HISTORIC AND DESIGN REVIEW COMMISSION

September 07, 2016

Agenda Item No: 19

HDRC CASE NO: 2016-337
ADDRESS: 423 MISSION ST
LEGAL DESCRIPTION: NCB 946 BLK 2 LOT 24
ZONING: RM4 H HS
CITY COUNCIL DIST.: 1
DISTRICT: King William Historic District
LANDMARK: House
APPLICANT: Fernando Morales/Candid Rogers Architect
OWNER: Pamela McClain
TYPE OF WORK: Porch repair, landscaping, accessory structure relocation and a rear addition
REQUEST:

1 DEMOLITION PLAN

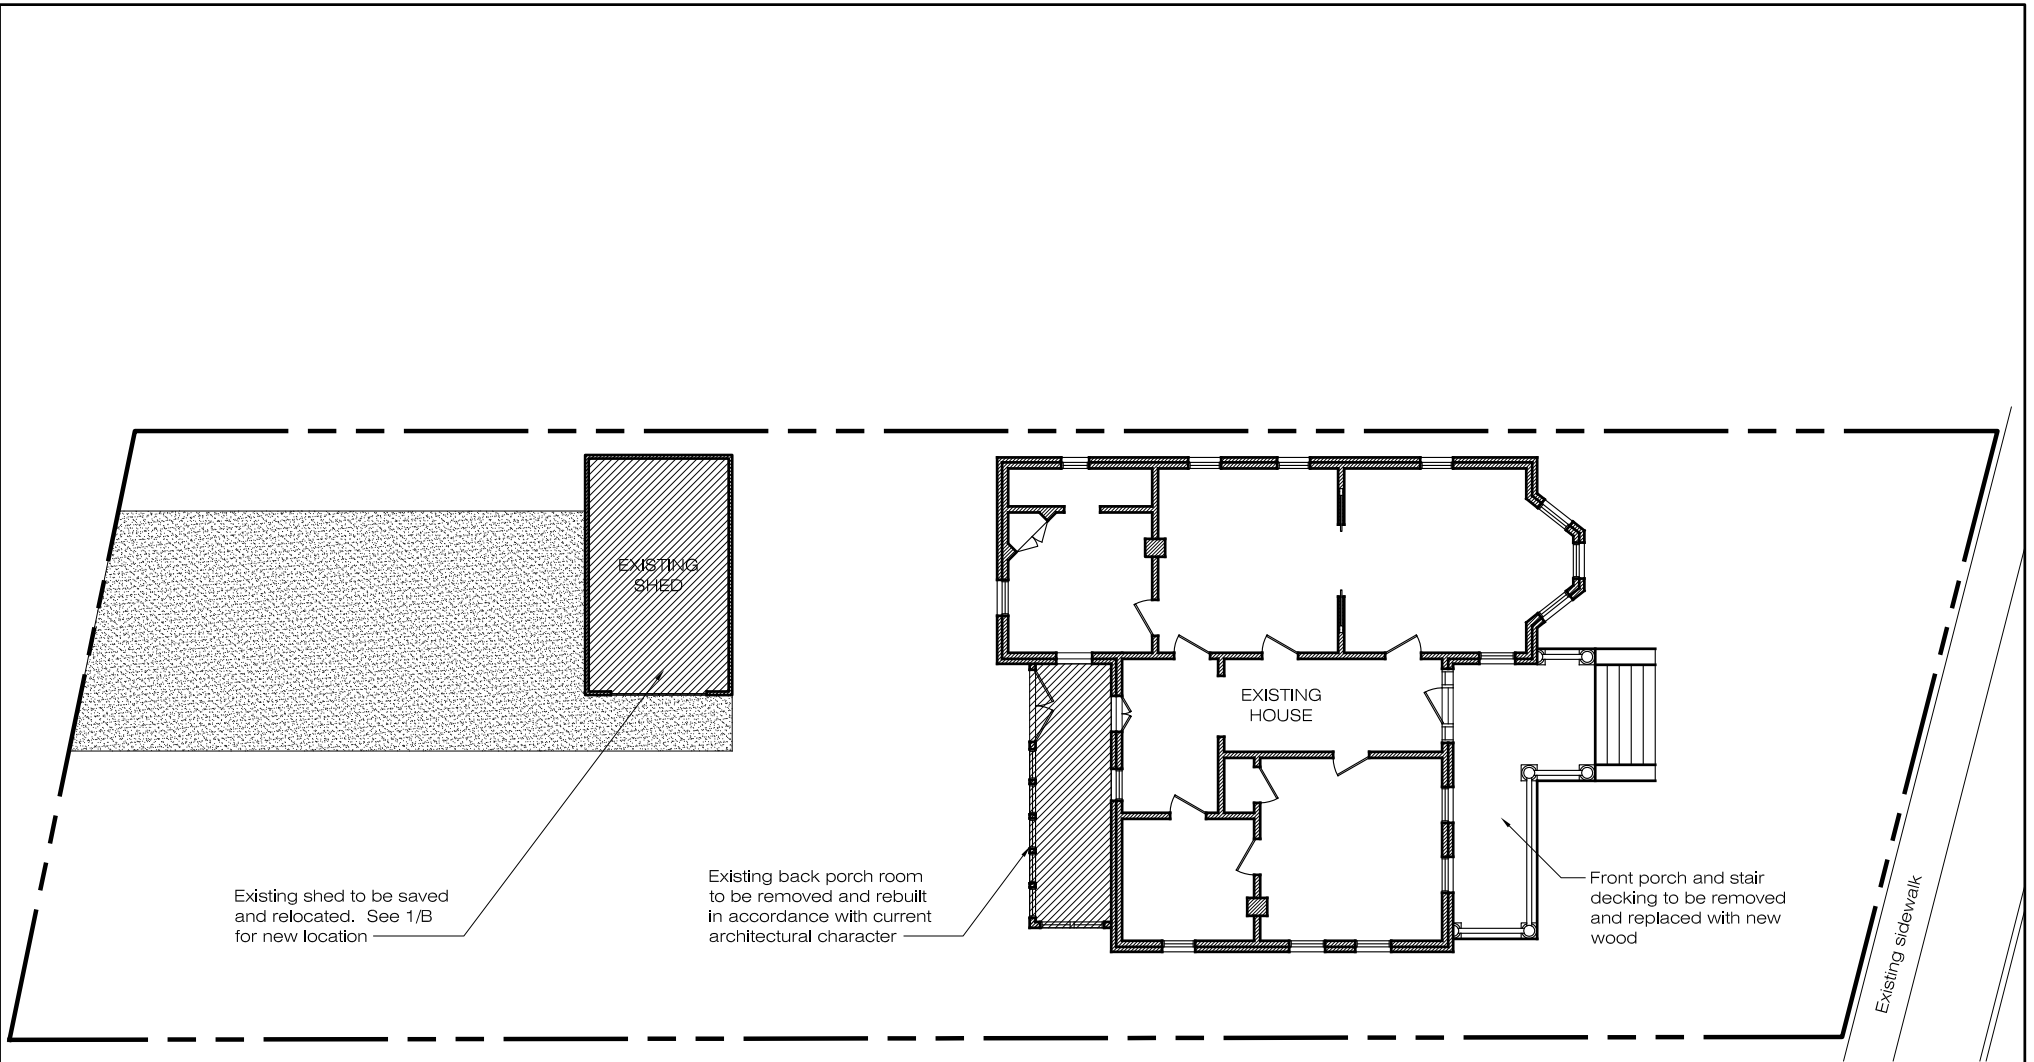
- d. **REAR PORCH RECONSTRUCTION** – The rear of the primary historic structure features an enclosed porch that appears on the 1912 Sanborn map. Due to the architecture of the porch enclosure, staff finds that this modification was made circa 1950. The enclosed porch currently features French doors with a transom the width of the door opening, five one over one wood windows and wood siding. The applicant has proposed to demolish the existing enclosed porch and construct a new porch with a matching footprint. The applicant has proposed for the reconstructed enclosed area to feature 1x6 wood siding, two fixed windows and a single width door. Staff finds the removal of the non-original porch enclosure appropriate and the applicant’s proposed materials appropriate and consistent with the Guidelines. The applicant’s use of shiplap siding distinguishes this non-original massing

- h. **ACCESSORY RELOCATION** – Currently, an accessory structure is located to the rear of the primary historic structure near the middle of the lot. The 1912 Sanborn maps show an accessory structure located in the northwest corner of the lot. The applicant has proposed to relocate the existing accessory structure to the southwest corner of the lot; consistent with the historic example in the King William Historic District. This is appropriate and consistent with the Guidelines. The applicant has noted a side setback of three (3) feet and a rear setback of (5) feet.

1 FLOOR PLAN
Scale: 1/16" = 1'-0"

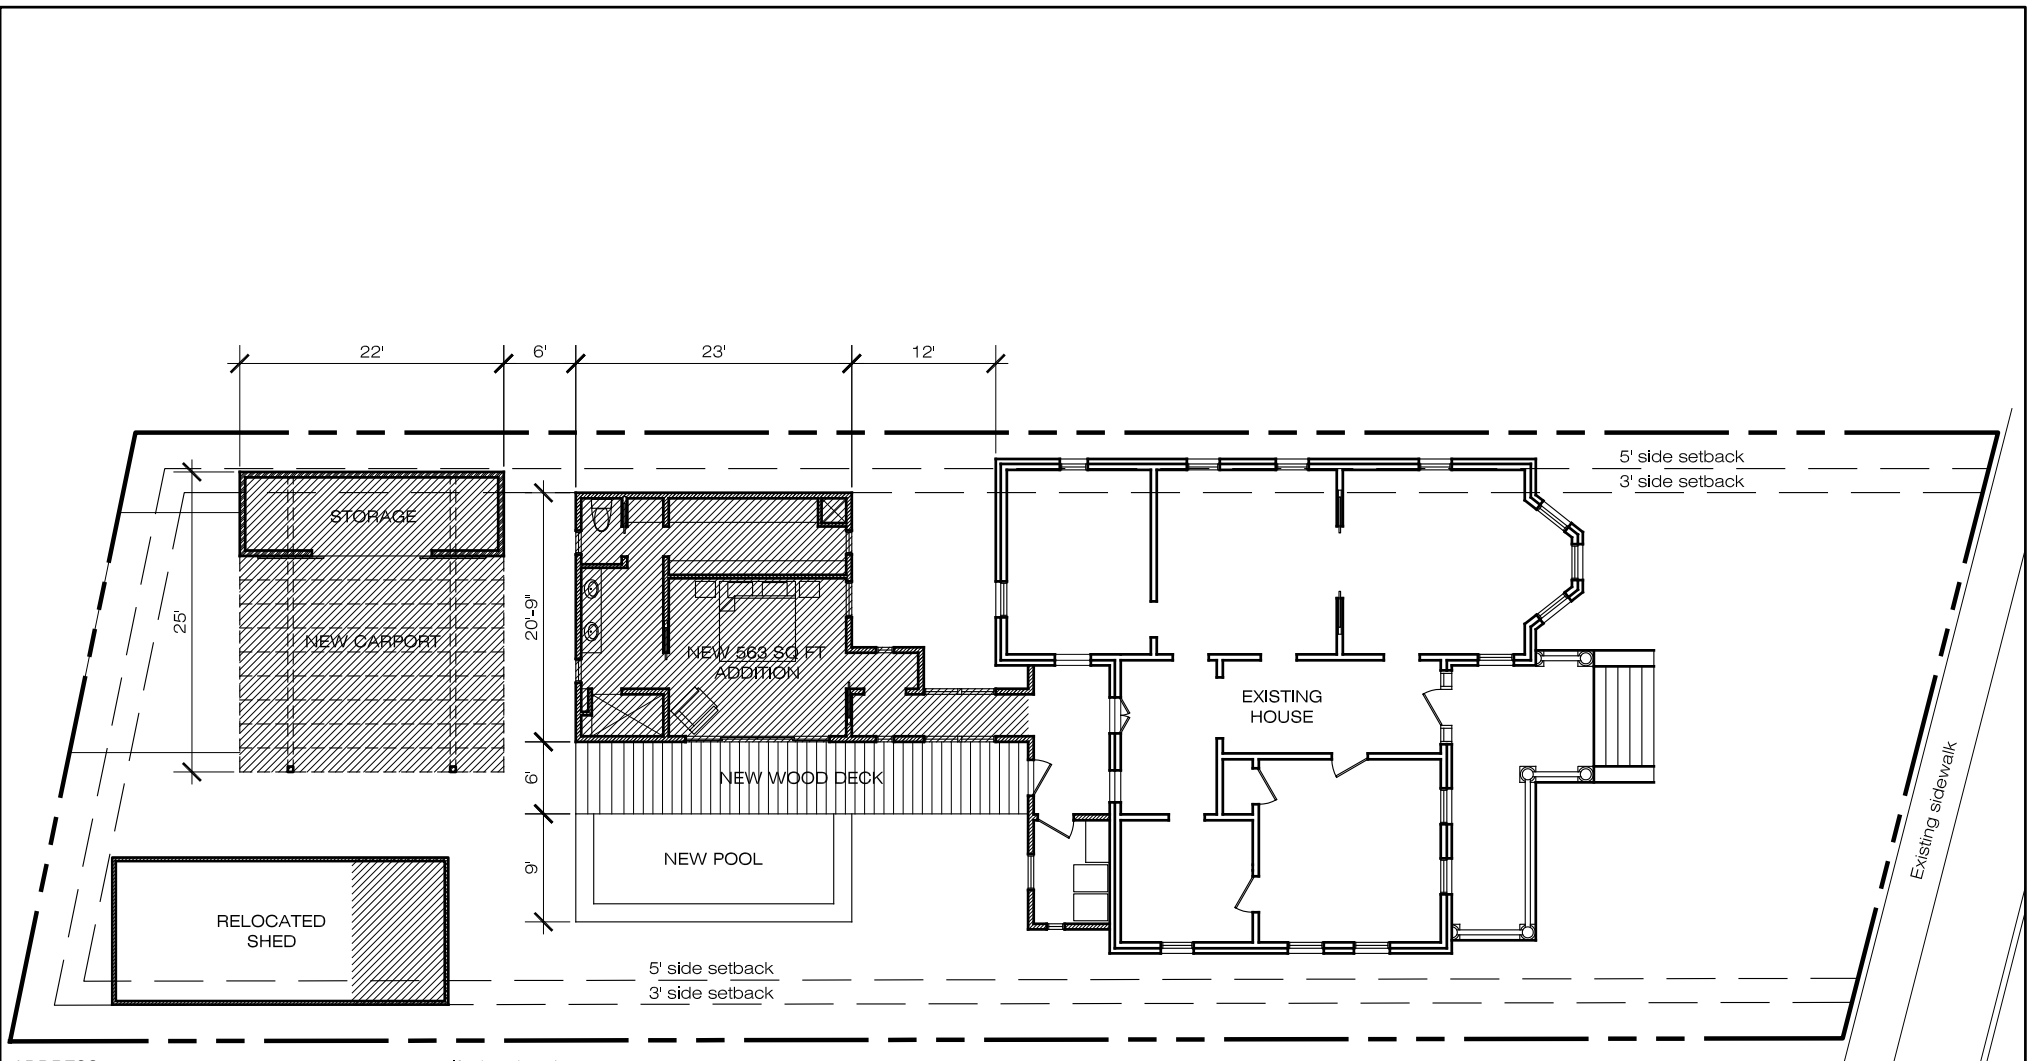
- e. **ADDITION** – West (to the rear) of both the primary historic structure and rear enclosure addition, the applicant has proposed to construct an addition of approximately 565 square feet. The Guidelines for Additions 1.A. states that additions should be sited to minimize visual impact from the public right of way, should be designed to be in keeping with the historic context of the block, should utilize a similar roof form and should feature a transition between the old and the new. The applicant has proposed for the addition to include a setback and visual transition from the primary historic structure and has sited the addition in a location that will not be visible from the public right of way. The applicant has proposed for the structure to include a flat roof; however, staff finds that given the lack of visibility from the public right of way, the proposed roof is appropriate.

- f. **SCALE, MASS & FORM** – Regarding scale, mass and form, the applicant has proposed for the addition to feature a roof height that is subordinate to that of the primary historic structure, a width that is subordinate to that of the primary historic structure and a footprint that is appropriate for the lot. To the south of the addition, the applicant has proposed a wood deck that is minimal in profile. This is consistent with the Guidelines for Additions 1.B

Staff recommends approval of items #1 through #7 based on findings a through j.
